**REVIEW OF JAMAICA PUBLIC SERVICE COMPANY, LTD
LEAST-COST EXPANSION PLAN**

**Decision and Information Sciences Division
ARGONNE NATIONAL LABORATORY
9700 S. Cass Avenue, DIS/900
Argonne, IL 60439**

July 30, 1999

Figure 1: Projections of Fuel Prices

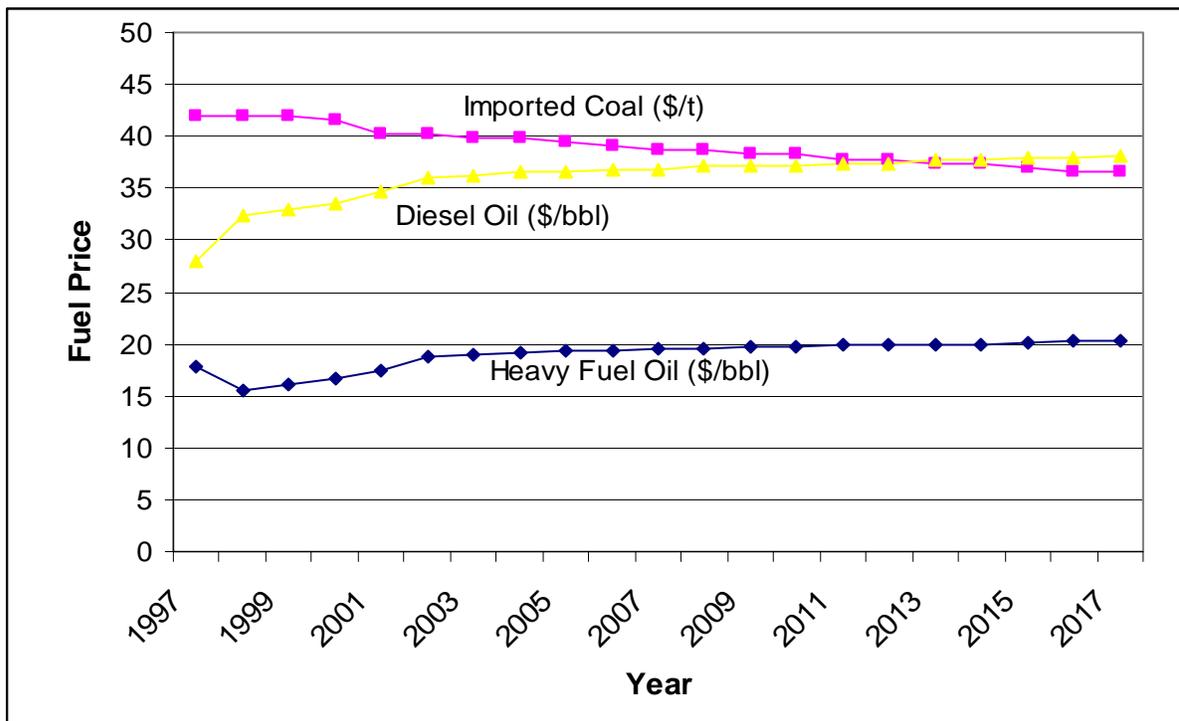
- The projections of fuel prices over the study period were reviewed in detail and compared to the latest projections available in the publication “International Energy Outlook 1999 with Projections to 2020,” published by the Energy Information Administration of the United States Department of Energy [DOE/EIA-0484(99)], April 1999. The EIA publication presents their own projections of energy prices (for three scenarios: reference case, high price case, and low price case), as well as forecasts developed by a number of U.S. and international institutions and organizations dealing with energy. In addition, for the purpose of LCEP review, other sources that provide long-term projections of fuel prices have been consulted (e.g., The World Bank, British Petrol, etc.). The review concluded that the projections of fuel prices that were used for the LCEP analysis were closely following the general trends of projections obtained from the above sources. Based on the review of different projections, the expected market trends for major fuels can be summarized as follows. Oil prices are expected to quickly rebound from the low level experienced in 1998 to about 20 U.S.\$/bbl and then to remain constant or have a slight positive escalation thereafter. Coal prices are expected to continue to decline with a negative escalation rate of about 1.5% per year. Natural gas prices are expected to have a small positive escalation rate of 0.8% per year, however natural gas is not currently a viable fuel supply option in Jamaica. For comparison, the projections of fuel prices that were used in the analysis of the new base case are illustrated in Figure 1.

Figure 2: Screening Curves for Candidate Technologies

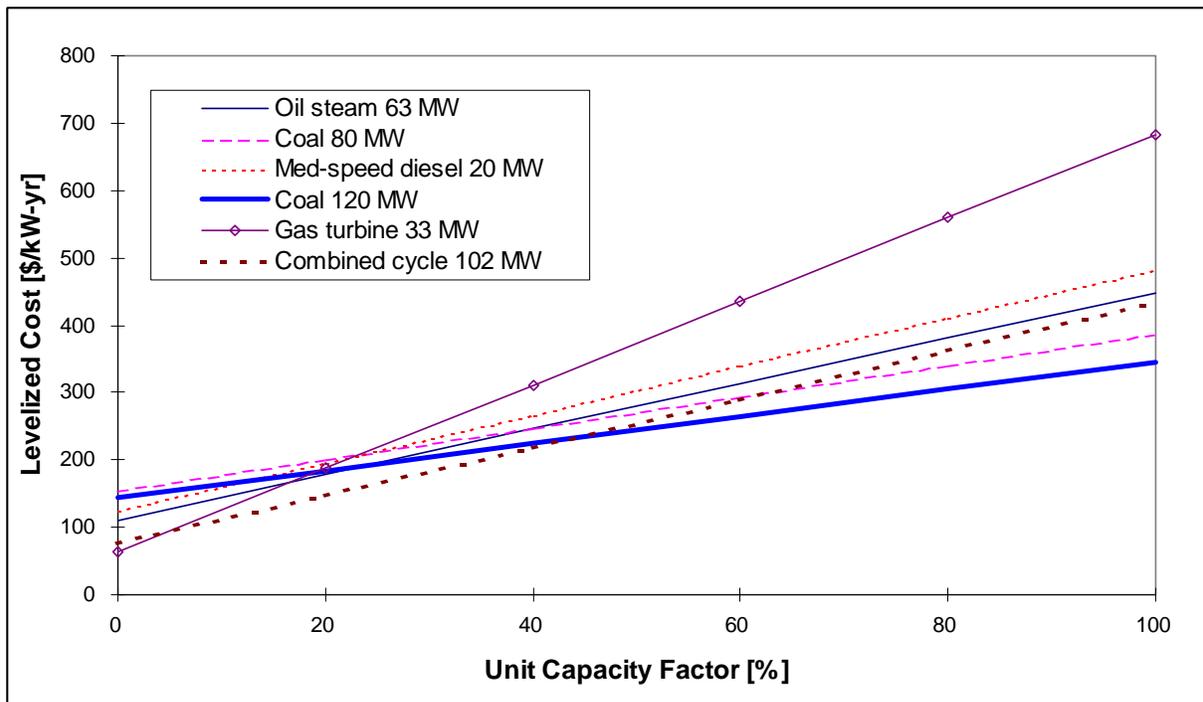
- A new set of screening curves for candidate technologies was constructed to perform a preliminary assessment of the effects of changes introduced into the new base case on the expansion candidates. By plotting the levelized cost of electricity production of candidate technologies as a function of their annual utilization (or capacity factor of generating units), the screening curves provide an indication of their competitiveness for system expansion. Of course, the actual optimization of the system development with the WASP model is much

more complex and takes into account many different aspects not addressed by the relatively simplistic screening curve approach. Nevertheless, the screening curve analysis is very useful, especially in the preparation phase for the systems planning exercise, and helps detect certain data inconsistencies and illustrate relative merits of candidate technologies. Figure 2 shows screening curves constructed for the expansion candidates in the new base case analysis.
